MUNICIPAL CORPORATION,
KARACHI.

NOTICE OF DEVIATION FROM APPROVED PLAN.

Re:—Plot No. *24.* Sheet No. *W. 06*, *Wadhwanal P. Quarter.*

PLAN SHOWING PROPOSED ADDITIONAL
CONVENIENCES FOR S.No. 24 W.O. 6 WADHUMAL QST
SCALE 8'-1"

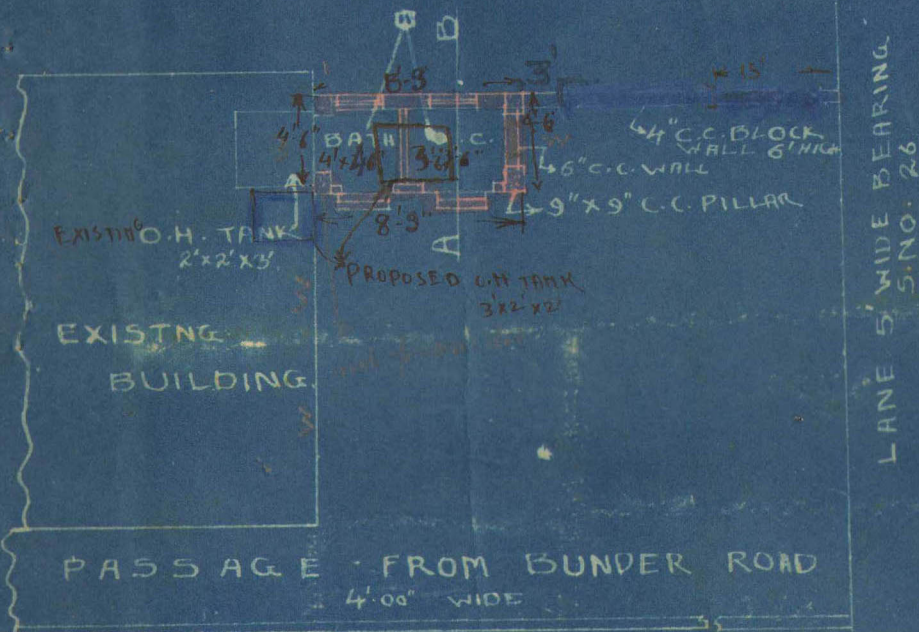
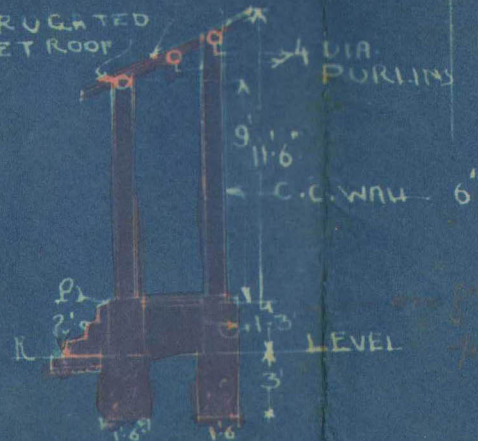
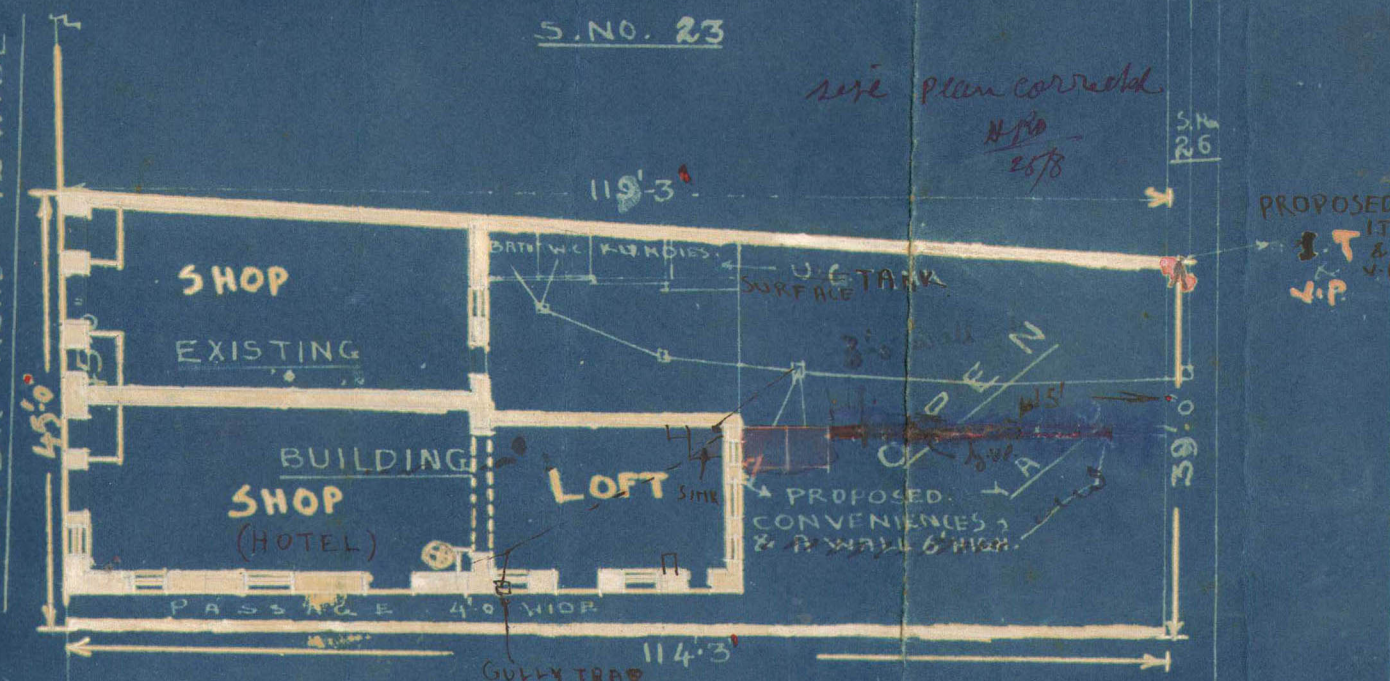
You are hereby informed that you are carrying out, or have carried out the construction work on the above plot in a manner contrary to the approved plan, as follows—

- (1) *Two 9" x 9" C.C. pillars near the existing building are not provided.*
 - (2) *Roof is not in order.*
 - (3) *Two feet plinth is not provided.*
- Hence your building ^{completion} certificate cannot be considered.*

With reference to your letter No 371/42 dated 4th inst I have to state that the W.C. is made 2' higher than road level & 0'6" from inner Court yard.

As regards 2 c.c. pillars you will allow me to correct the plan, as the lintels are introduced in the wall instead of lecting pillars
Thanking you.
